Access Compliance Report

Public Rights-of-Way

(Curb Ramps)

Intersection ID: 47909	Main Street: MOUNTAIN_QUAIL_DR	Cross Street: HARRIER_RD	Location:	N
ADA ID: 9E26A2E40D82	Ramp Type: PerpDiag	Initial Pass/Fail: Fail	Overall Compliance: No	Severity Score: 21.25

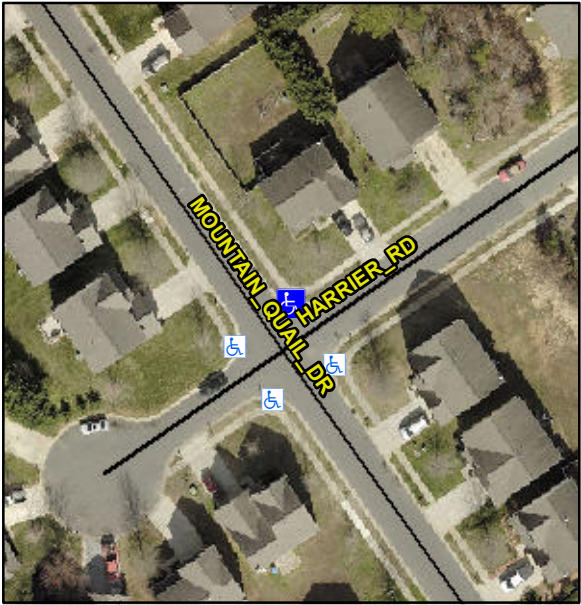
Codes/Mitigation Info/Possible Solution		Field Measurements/Component Compliance			
 Street 1 Name MOUNTAIN QUAIL DR Stop Condition-Street 2 None Street 2 Name HARRIER RD Stop Condition-Street 1 StopSign	Possible Solutions:	Remove & Replace Curb Ramp With Two New Directional Ramps or Equivalent.			
	Surveyor Notes:	N/A			
	PROW/ADA:	Not Found, R304.5.1, R304.5.3			
	Total Cost:	\$ 3200.00			
			Compliance	Description	Data
			Yes	Ramp Length (in)	53.5
			No	Ramp Width (in)	38.5
			N/A	Flare Type LT	N/A
			N/A	Flare Slope LT (%)	N/A
			N/A	Flare Traversable LT?	N/A
			N/A	Landing Length (in)	N/A
			N/A	Landing Width (in)	N/A
			N/A	Landing Slope (%)	N/A
			N/A	Landing X Slope (%)	N/A
			N/A	Landing Curb? (Y/N)	N/A
			N/A	Shared Landing?	N/A
			N/A	Gutter Ponding?	N/A
			N/A	Gutter Lip Ht (in)	N/A
			No	Painted X Walk1?	No
			To SW	X Walk 1 Direction	To SE
			N/A	X Walk 1 Width (in)	N/A
